KANSAS GAS AND ELECTRIC COMPANY

KMLNRC 86-071
Re: Docket No. STN 50-482
Ref: 1) Letter KMLNRC 85-122 from GLKoester, KG&E,
to HRDenton, NRC, dated 5/22/85
2) Letter from BJYoungblood, NRC, to GLKoester, KG&E,
dated 8/16/85
Subj: Low Temperature Overpressure Protection

FIGURE 1

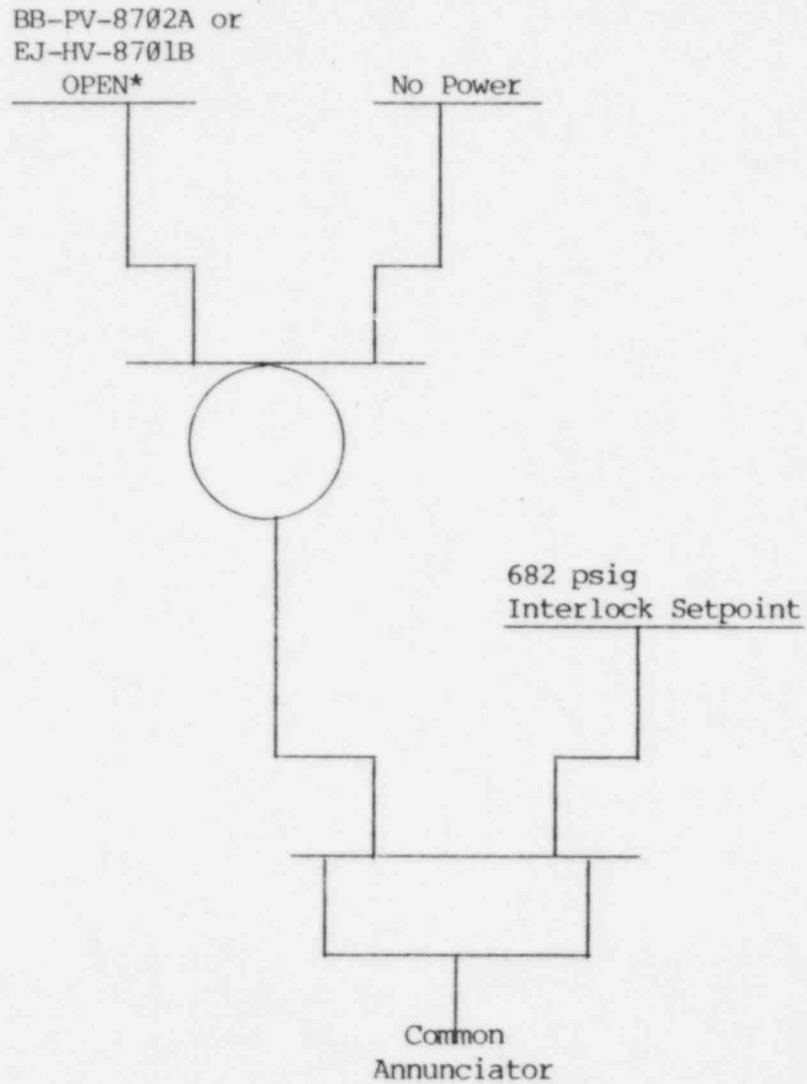
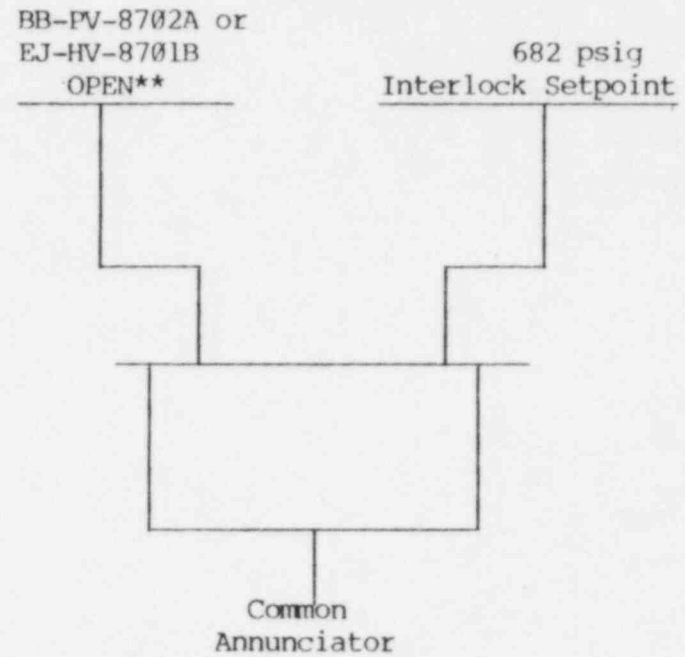
During the development of the installation package, it was determined that the design proposed in Reference 1 would perform its intended function, but would produce alarms that could not be cleared even with correct valve alignment. This is because the alarms would be generated above the closure interlock activation setpoint of 682 psig when power was removed from BB-PV-8702A as procedurally required. In order to remedy this situation, Kansas Gas and Electric Company (KG&E) proposes modified alarm circuits which will alarm if either valve BB-PV-8702A or EJ-HV-8701B is open at pressures above the interlock setpoint. A single annunciator window will represent these two alarm circuits, but they will be alarmed individually on the Balance of Plant Computer.

Figure 1 outlines the design as described in Reference 1 and the modified design. The modified alarm circuits do not affect the analysis provided in Reference 1 with regard to compliance to Standard Review Plans 5.2.2 and 5.4.7 and the corresponding Branch Technical Positions RSB 5-2 and RSB 5-1. The valve position inputs for the alarms in the modified circuit come directly from valve stem mounted limit switches rather than from the motor control center inputs as in the previous design. The modified circuit continues to provide annunciation in the control room for misaligned valves once the interlock setpoint is reached. An alarm response procedure will direct the operator to verify valve closure upon receipt of this alarm.

Present NRC Approved Design
(Ref: KMLNRC 85-122)

Modified Design
